ADDENDUM NUMBER 2ISSUED September 9, 2010

**WASHINGTON COUNTY SERVICE AUTHORITY
MIDDLE FORK WTP UPGRADE TO 12 MGD**

Prepared by: Olver - A CHA Company
1116 South Main Street
Blacksburg, VA 24060
Olver Project No.: 12367.13

CHANGE TO SHEET A260

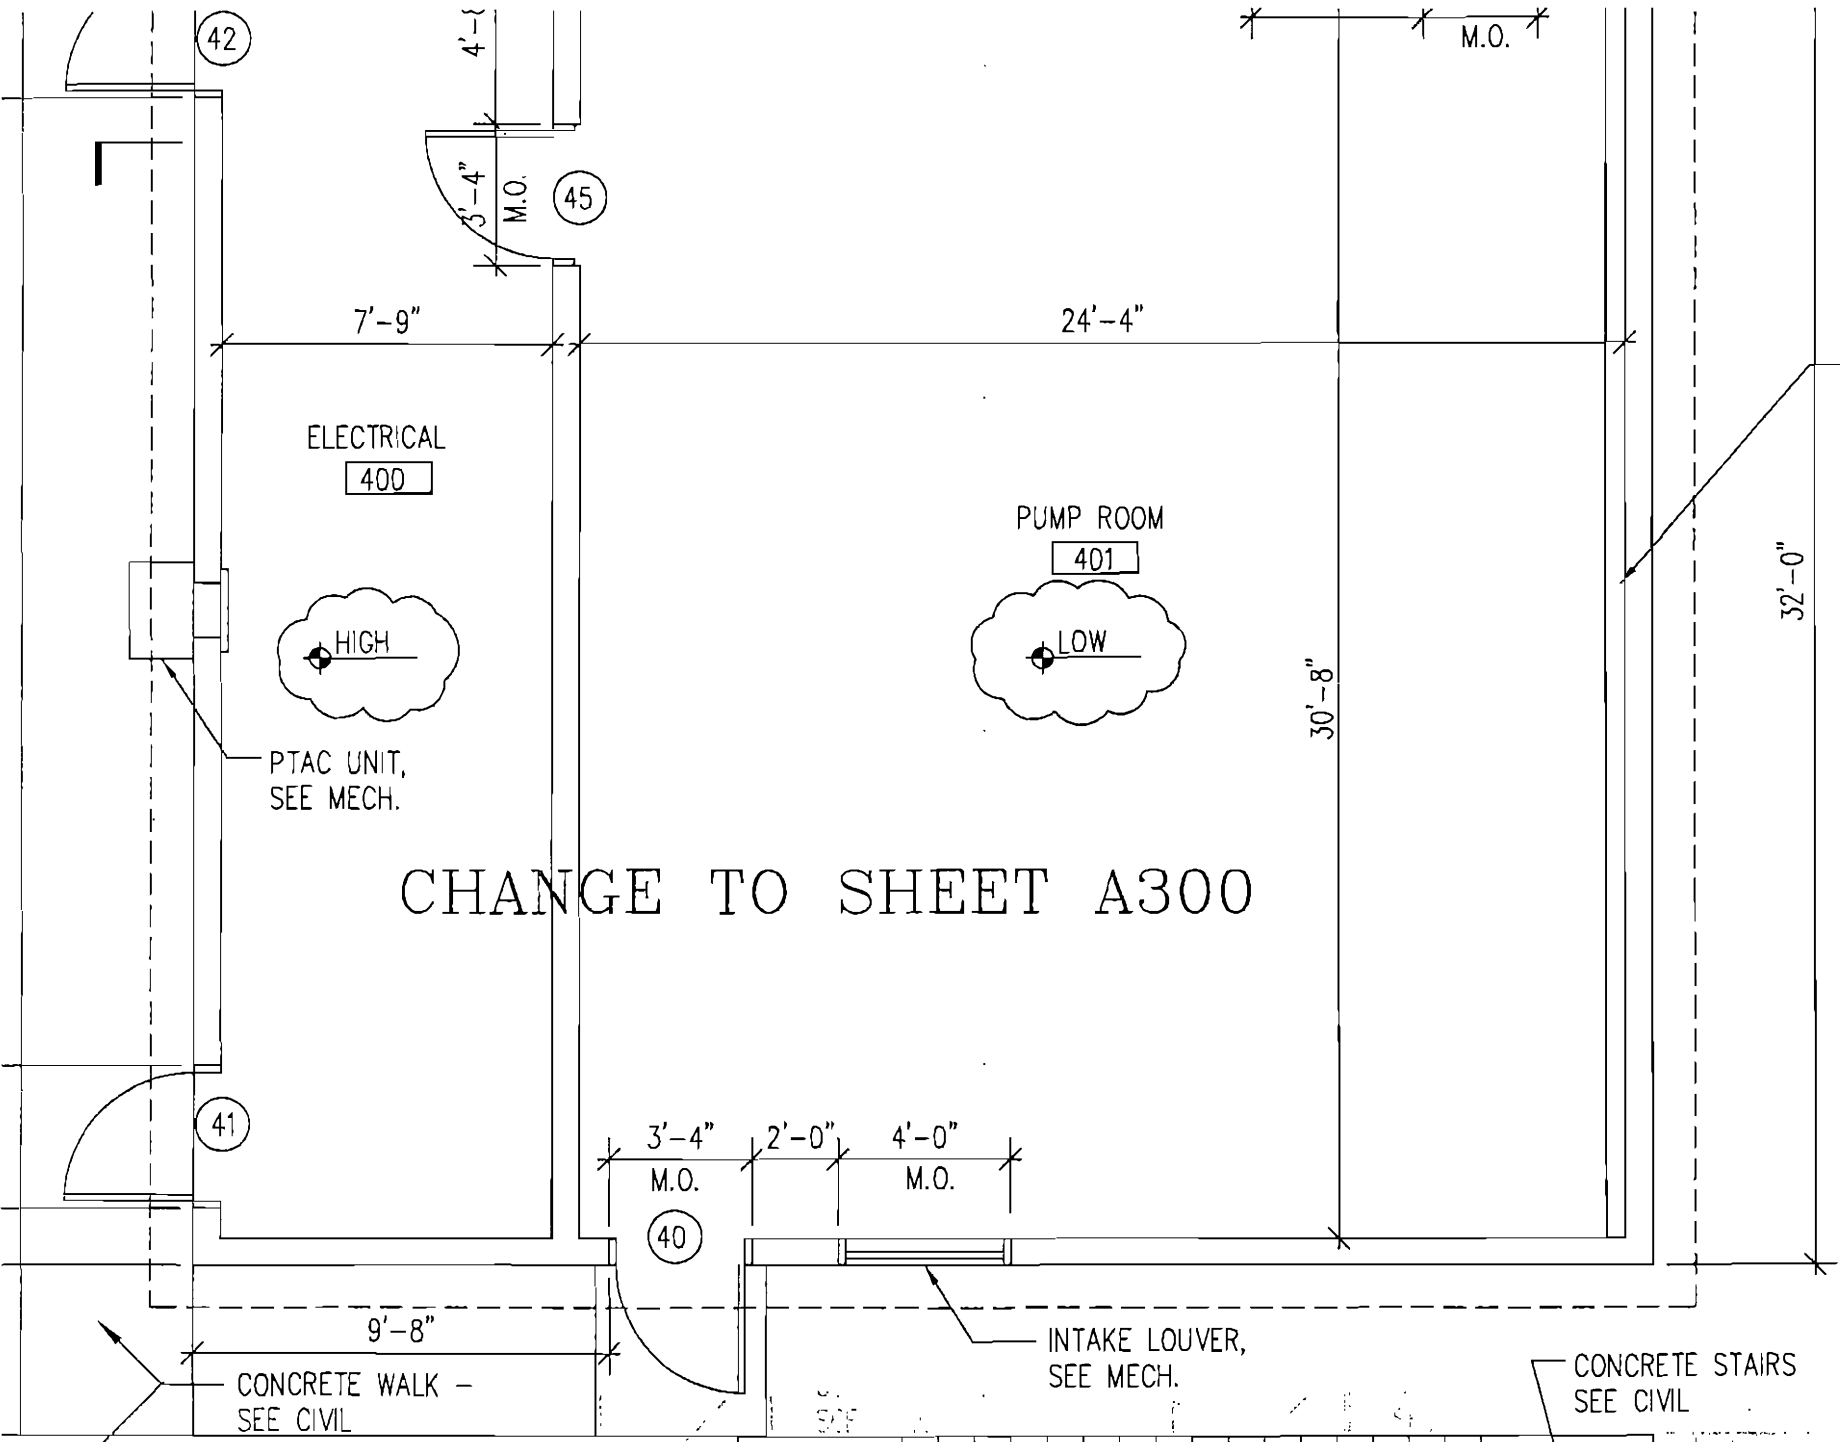
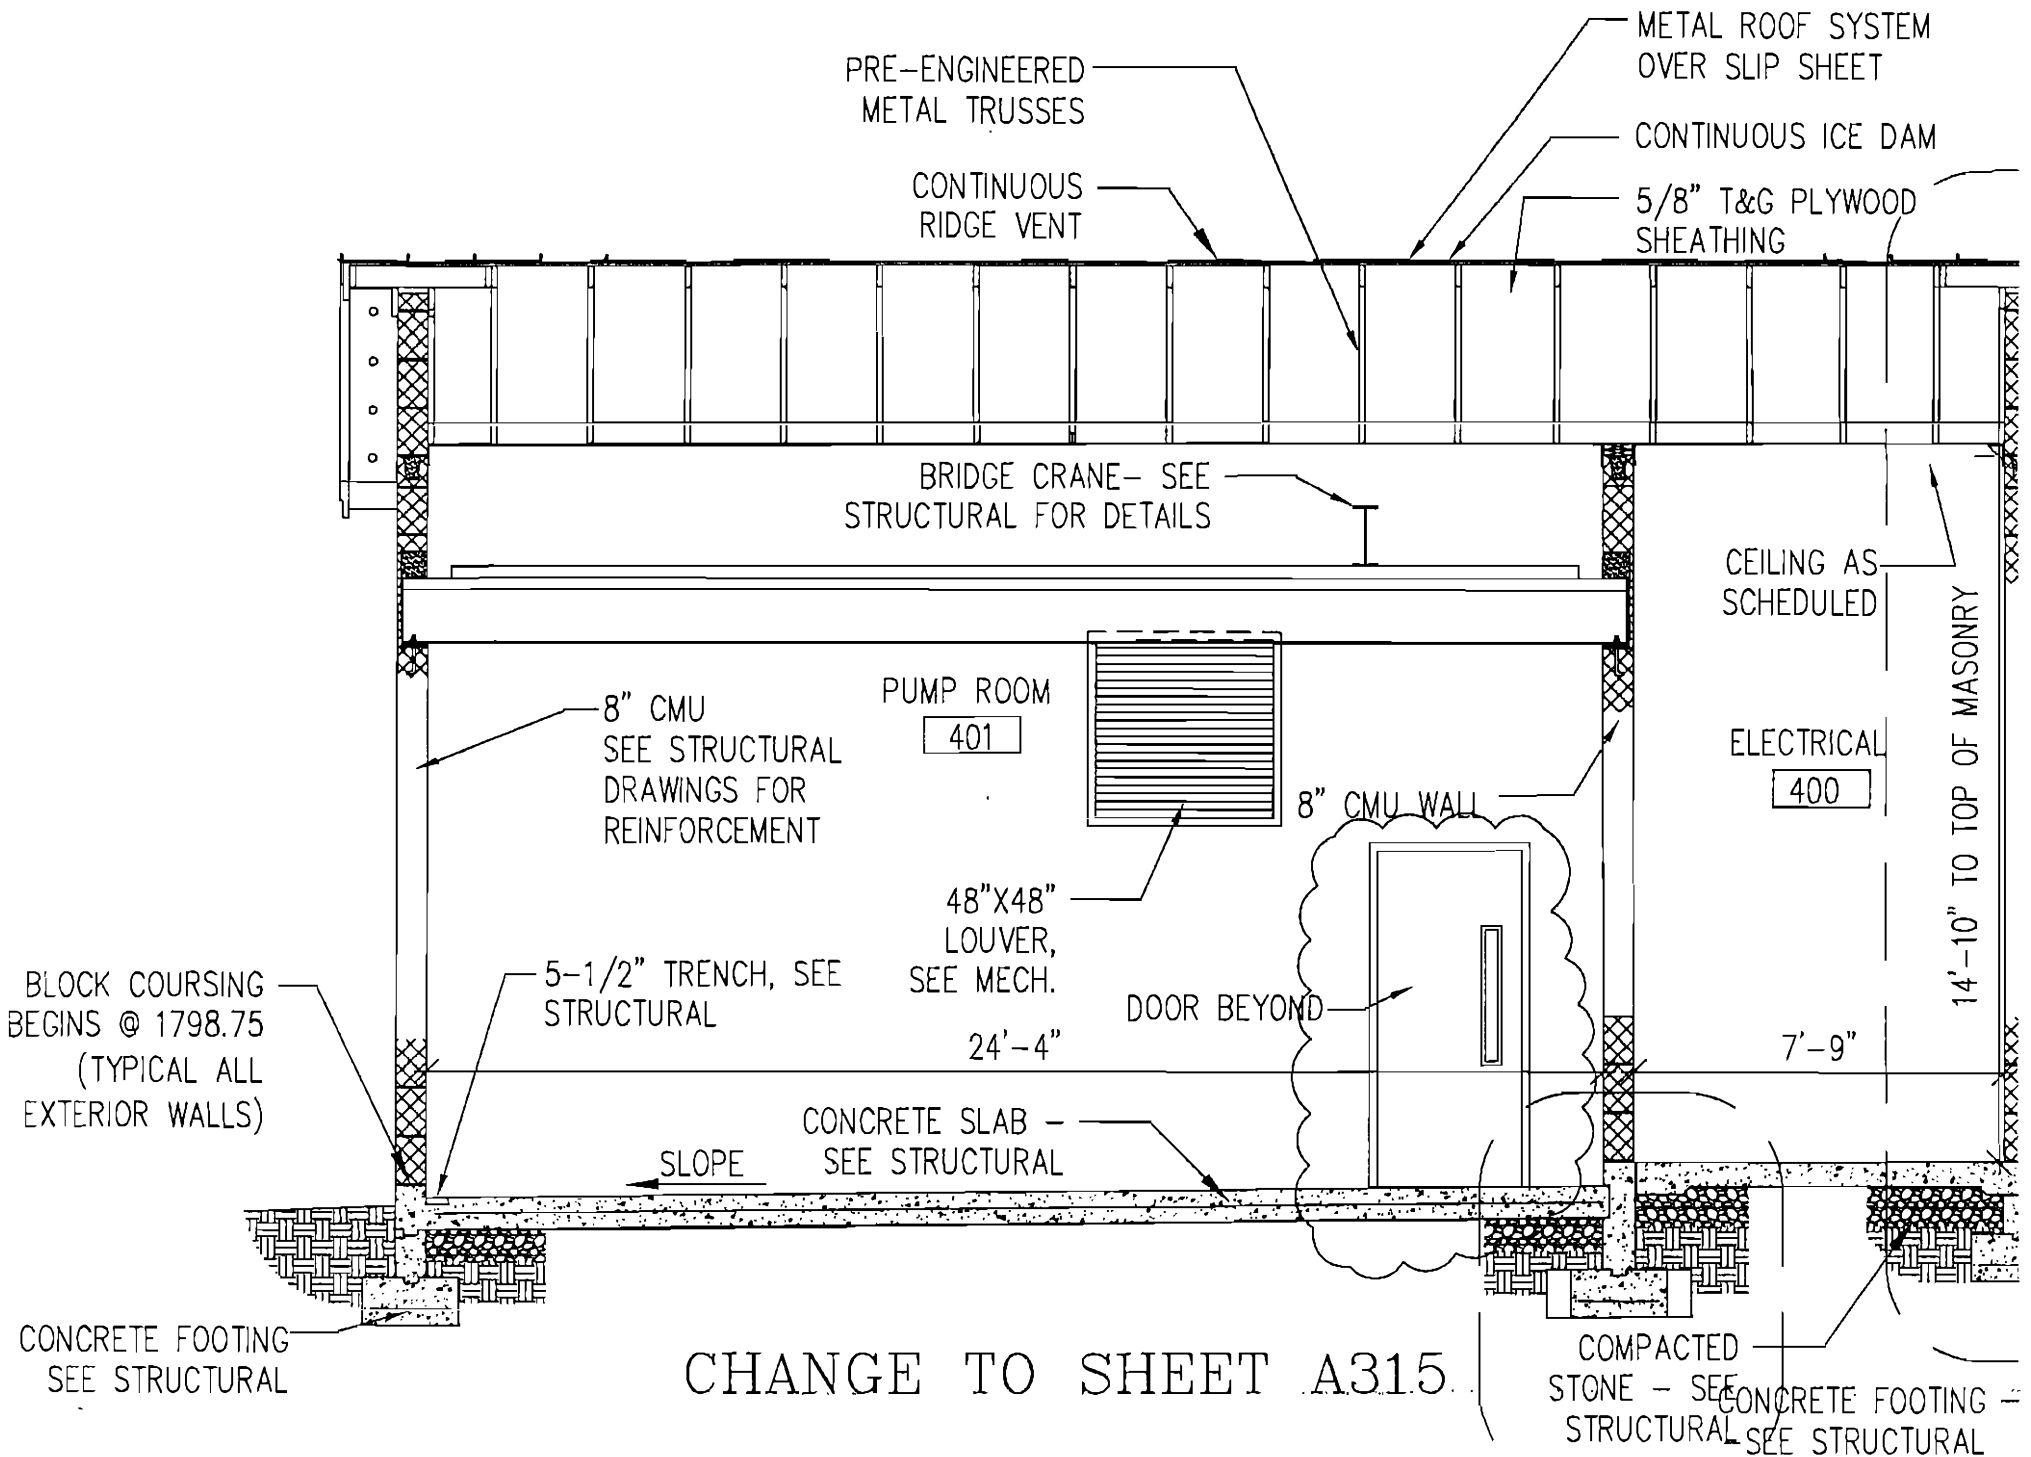
- AD2-179 Modify the following plan sheets per the attached details: A100, A134, A135, A142, A160, A170, A200, A260, A300, A315 and A360.
